# CHEVROLET

# SERVICE NEWS

MARCH, 1961

## HYDRAULIC LIFTERS USED IN V-8 AND CORVAIR ENGINES

Fig. 1—Installing Spring Ring Clamp

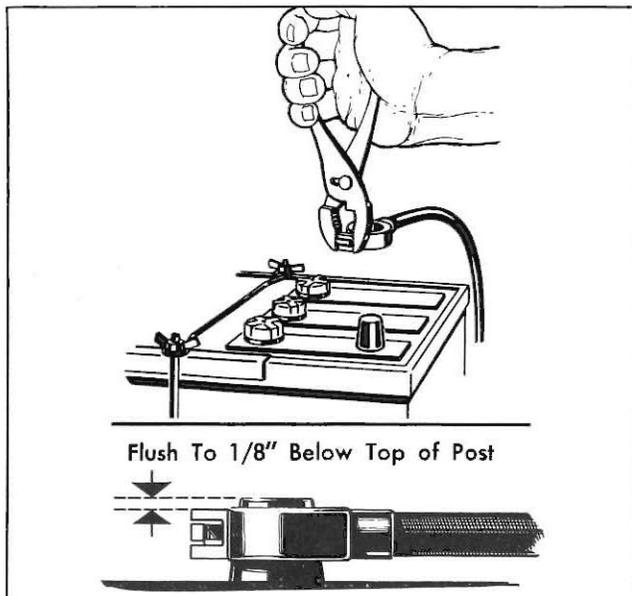
Battery cables now being used on all 1961 vehicles utilize a battery post terminal clamp that

incorporates a spring steel core. The new Spring Ring terminal provides more positive clamping, and also facilitates disconnecting of battery leads as recommended in numerous service procedures.

To remove the cable terminal from the battery post, grasp terminal tangs with pliers (Figure 1) and squeeze until the end of the single tang (present on one side) is flush with the stop formed by the base of the other two tangs. With the clamp held open in the above manner, it can be easily lifted off the battery post.

To install the cable terminal on the battery post; hold terminal squeezed open, as in terminal removal, while pushing the terminal as far as possible onto the post. When installed, the terminal should be flush to approximately  $\frac{1}{8}$  inch below top of post. After assembly of clamp to the battery post, apply a light film of oil or grease to the post area.

**CAUTION:** Do not hammer or otherwise drive terminal onto post. The post contacting surface of the clamp should not be filed or reamed as it could damage the built-in spring.

Fig. 2—Folding Top Alignment Areas

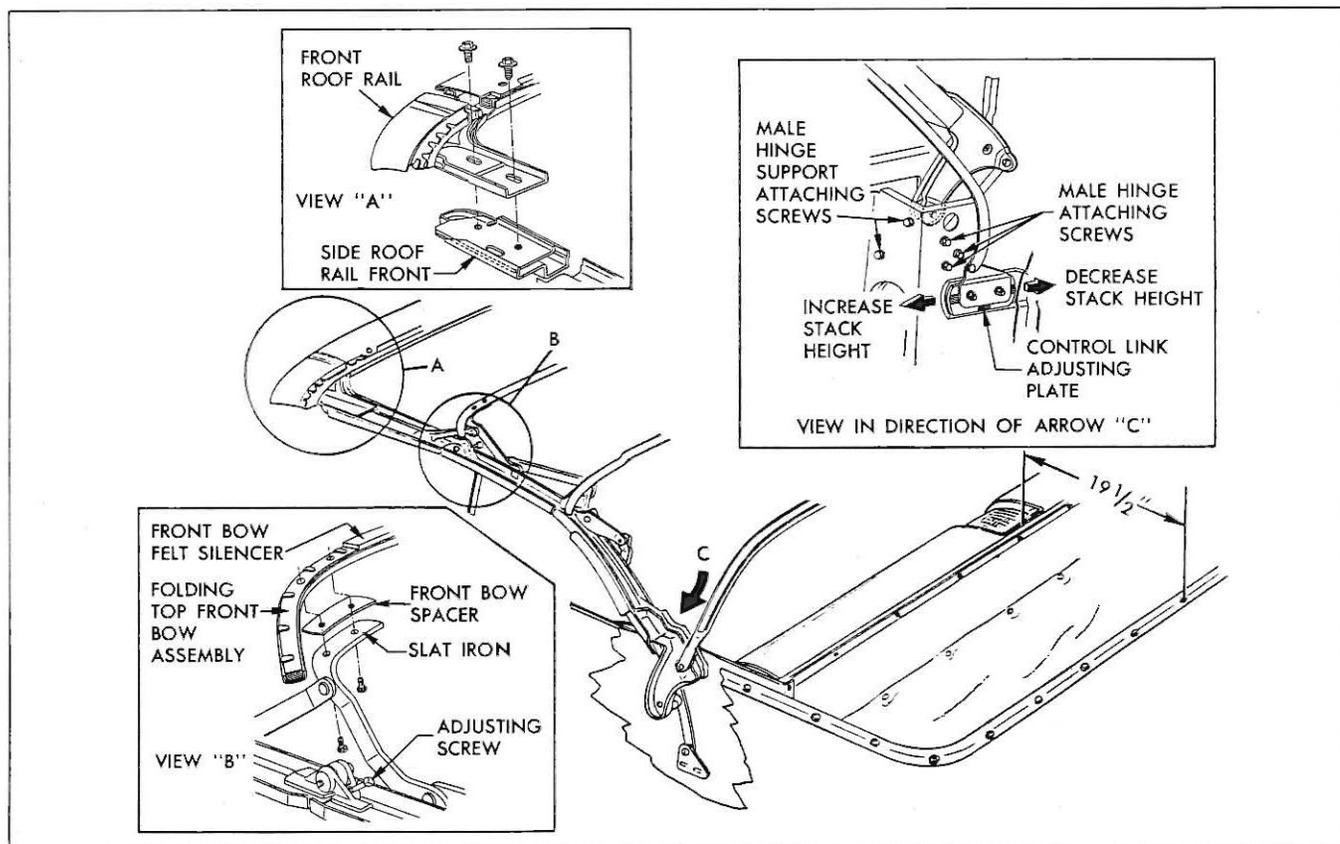
The following chart describes various types of folding top misalignment conditions, their causes and the recommended procedure for their correction. To correct some top variations, only a single adjustment is required; other top variations require a combination of adjustments. In conjunction with adjustment of the folding top assembly it may be necessary to adjust the door, door glass, rear quarter glass, trim sticks or side roof rail weatherstrips.

CONDITION	APPARENT CAUSE	CORRECTION
<b>Difficult locking action at front roof rail.</b>	Sunshade support misaligned. Lock hook lever improperly adjusted. Misaligned front roof rail front weatherstrip. Front roof rail misaligned.	Adjust sunshade support laterally. Adjust lock hook lever counterclockwise. Loosen, realign and retack front roof rail front weatherstrip. Adjust front roof rail.
<b>Top does not lock tight enough to windshield header.</b>	Sunshade support misaligned. Lock hook lever improperly adjusted. Misaligned front roof rail front weatherstrip. Front roof rail misaligned.	Adjust sunshade support laterally. Adjust lock hook lever clockwise. Loosen, realign and retack front roof rail front weatherstrip. Adjust front roof rail.
<b>Top travels too far forward.</b>	Front roof rail misaligned. Male hinge assembly misaligned.	Adjust front roof rail rearward (See Figure 1—View "A"). Adjust male hinge rearward (View "C").

<b>Top does not travel forward far enough.</b>	Front roof rail misaligned. Male hinge assembly misaligned.  Improper spacing between rear trim stick and body metal.	Adjust front roof rail forward (View "A"). Adjust male hinge assembly forward (View "C").  Install an additional spacer between rear trim stick and body metal at each attaching bolt location.
<b>Side roof rail rear weatherstrip too tight against rear of rear quarter window.</b>	Male hinge assembly misaligned.	Adjust male hinge assembly rearward (View "C").
<b>Gap between side roof rail rear weatherstrip and rear of rear quarter window.</b>	Male hinge assembly misaligned.	Adjust male hinge assembly forward (View "C") and/or shim side roof rail rear weatherstrip forward as required.
<b>Side roof rail rear weatherstrip too tight against top of rear quarter window.</b>	Male hinge support misaligned.	Adjust male hinge support upward (View "C").

<b>Gap between side roof rail rear weatherstrip and top of rear quarter window.</b>	Male hinge support misaligned.	Adjust male hinge support downward (View "C") and/or shim side roof rail rear weatherstrip downward.
<b>Sag at front to center side roof rail joint.</b>	Control link adjusting plate misaligned. Center side roof rail hinge adjusting screw improperly adjusted.	Adjust control link adjusting plate downward (View "C"). Adjust screw counterclockwise (View "B").
<b>Wind whistle or waterleak along front roof rail.</b>	Top does not lock tight enough to windshield header. Misaligned, front roof rail front weatherstrip. Front roof rail contour does not conform to windshield header.	Adjust sunshade support laterally and/or adjust lock hook lever clockwise. Retack front weatherstrip to front roof rail. Contour of front roof rail may be changed slightly by reforming rail.
<b>Folding top dust boot fits too loosely.</b>	Improper stack height due to misaligned control link adjusting plate. Rear seat back assembly is too far rearward.	Adjust control link plate forward (View "C"). Relocate rear seat back panel forward until distance between upper rear edge of rear seat back to forward edge of pinchweld finishing molding is $19\frac{1}{2}$ inches $\pm \frac{1}{16}$ ". The dimension is measured at approximate centerline of body (see Figure 1).

CONDITION	APPARENT CAUSE	CORRECTION
Front and center side roof rails bow upward at hinge joint.	Control link adjusting plate misaligned. Center side roof rail hinge adjusting screw improperly adjusted.	Adjust control link adjusting plate upward (View "C"). Adjust screw clockwise (View "B").
Folding top dust boot is difficult to install.	Improper stack height due to misaligned control link adjusting plate. Misaligned folding top dust boot female fastener.  Rear seat back assembly is too far forward.  Excessive build-up of padding in side roof rail stay pads.	Adjust control link plate rearward or forward as required (View "C"). Align boot female fastener by trimming edge of fastener mounting plate. To remove plate for rework, slit inner layer of boot rubber reinforcement along side edge of plate. Relocate seat back panel rearward until distance between upper rear edge of seat to forward edge of pinchweld molding is $19\frac{1}{2} \pm \frac{1}{16}$ " (see Fig.1). Repair side stay pads as required.

Top material is too low over windows or side roof rails.	Front roof bow improperly shimmed.  Excessive width in top material.	Install one or two $\frac{1}{8}$ " shims between front roof bow and slat iron (View "B"). W/shims use 4824257 screw ( $\frac{1}{8}$ ") If top is too large, trim off excessive material along side bindings as required; then hand sew binding to top material.
Top material is too high over windows or side roof rails.	Front roof bow improperly shimmed.  Front roof bow felt silencer too high.	Remove shim from between front roof bow and slat iron (View "B"). Trim silencer to within $\frac{1}{8}$ " of top of front roof bow (View "B").
Top material has wrinkles or draws.	Rear quarter trim stick improperly adjusted. Top material improperly installed to center or rear quarter trim stick.	Adjust rear quarter trim stick on side affected. Retack top material as required.
